ZONING STAFF REPORT

Case No.: ZC15-10-070

PLAN REVIEW STAFF REPORT

PR15-10-004

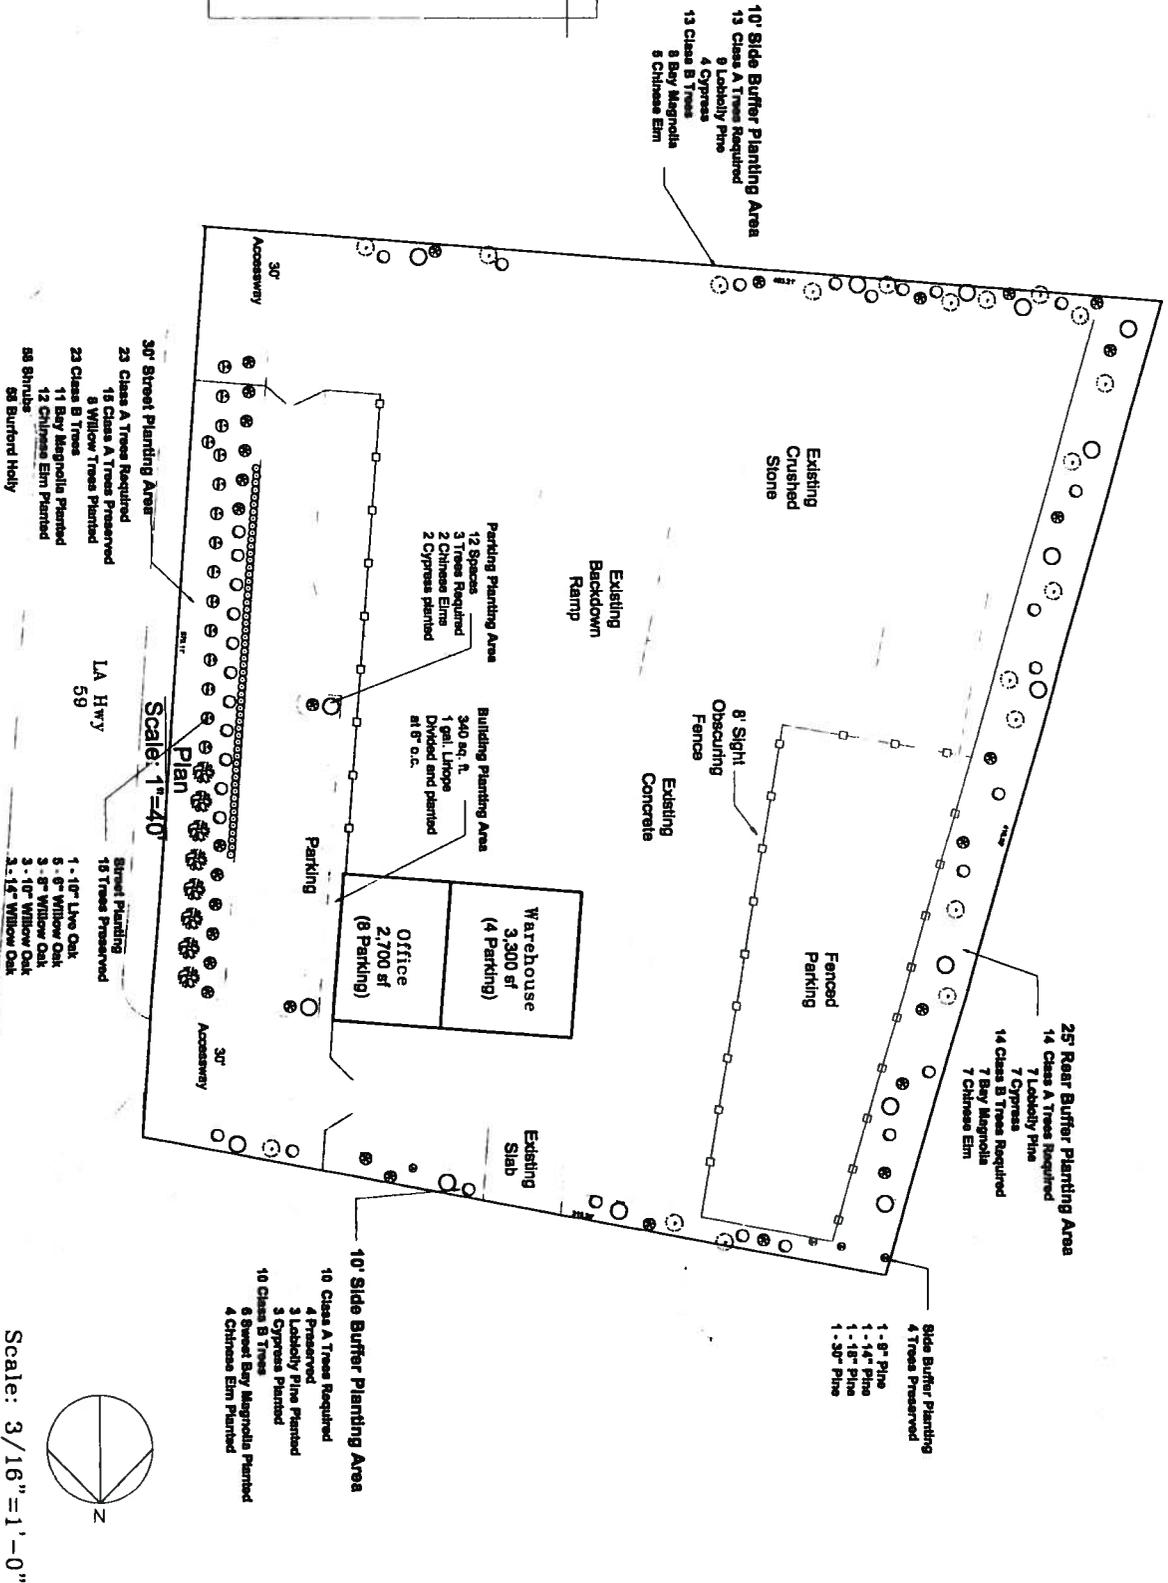
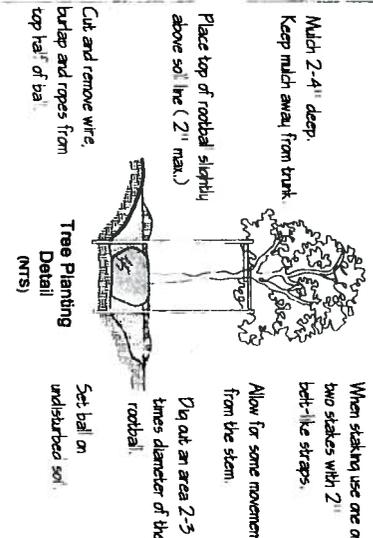
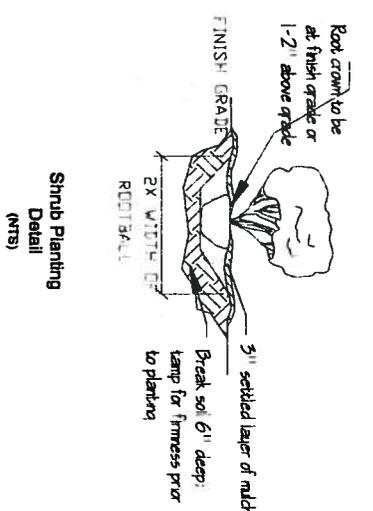
1. Provide a revised landscape plan meeting all the requirements. Note that a revised plan showing the size and location of all existing trees to be preserved and any new plant materials to meet the applicable landscaping requirements, will have to be provided before final inspection if some of the species of trees are being changed. Provide the size, caliper and species of the proposed trees on the revised landscape plan. Note that the size of the Class A & Class B trees has to be a minimum of 10' to 12' high. The caliper of Class A trees has to be a minimum of 2½" and the caliper of Class B trees has to be a minimum of 1½" measured at 1½ feet above the ground.

2. Revised the calculation of the tree credit within the front and northern greenspace.
3. Remove the 3 display pads, proposed to be located within the front greenspace area.

6. If a dumpster is required, provide the location and the required screening.
7. The property owner shall be responsible for the maintenance and the replacement of the required plant materials.

8. During construction, planting or open ground areas surrounding preserved trees shall be wired off with a properly flagged, reinforced & rolled wire mesh.

9. Sight triangle shall have 25 feet at the intersection of a public street and 15 feet along a private access way. No parking, wall, fence, sign, structure or plant material shall be placed within the sight distance area so as not to impede vision between a height of 2½ feet and 10 feet above the center line grades of the intersecting streets and/or drives.

10. No plant material except grass or ground cover shall be located closer than 3 feet from the edge of any access way pavement.
11. Provide an exterior lighting plan so all exterior lighting shall be shaded or inwardly directed in such a manner so that no direct lighting or glare is cast beyond the property line. The intensity of such lighting shall not exceed one foot candle as measured at the abutting property line. Outdoor lighting illumination shall follow the recommended guidelines for the luminescence as established in the IESNA Lighting Handbook.

FRONT ELEVATION

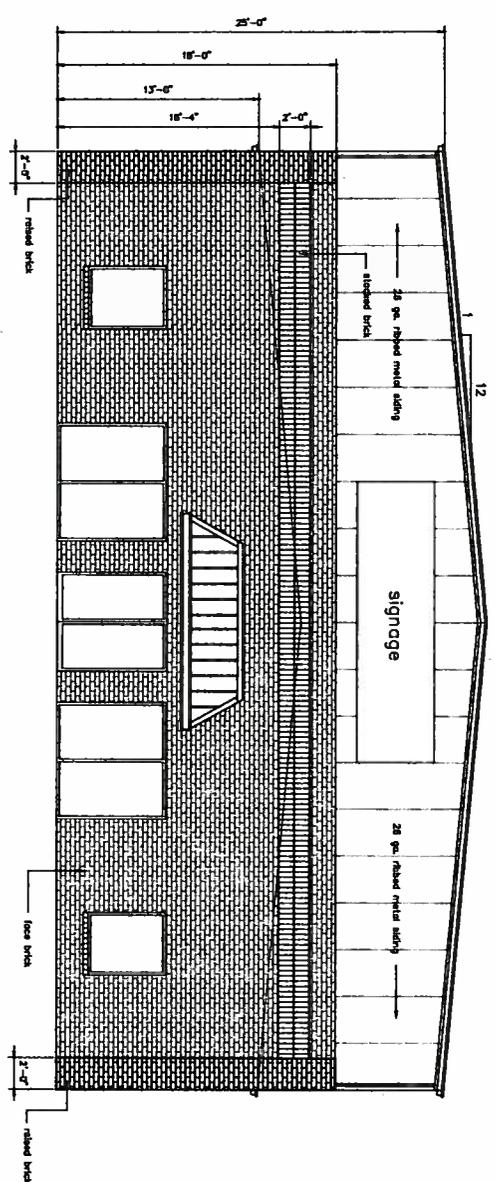
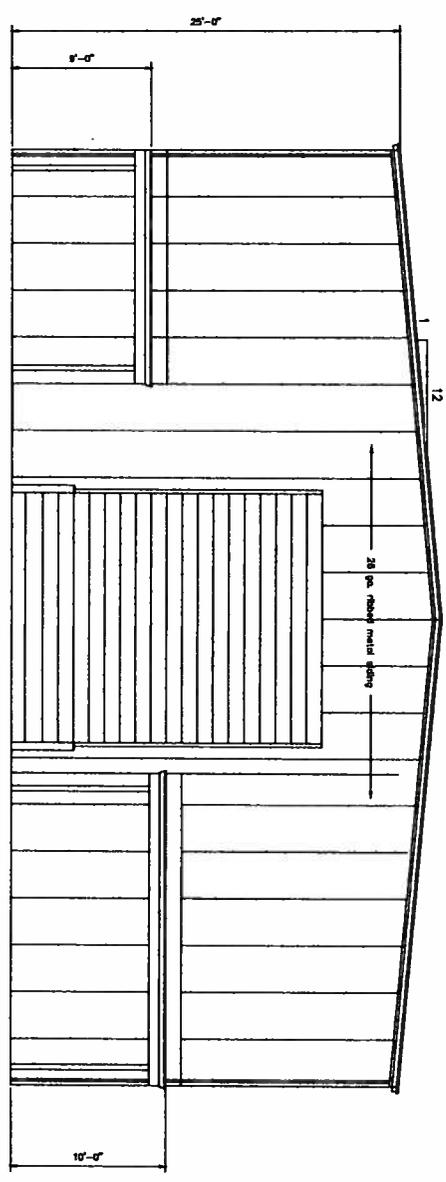
It is our intent to ask the Parish to allow us to Keep the back side of the building as per plans and not match the front façade of the building on the aforementioned property. In any event, please be advised that we are interested in assuring you that our request should not adversely affect the property interest.
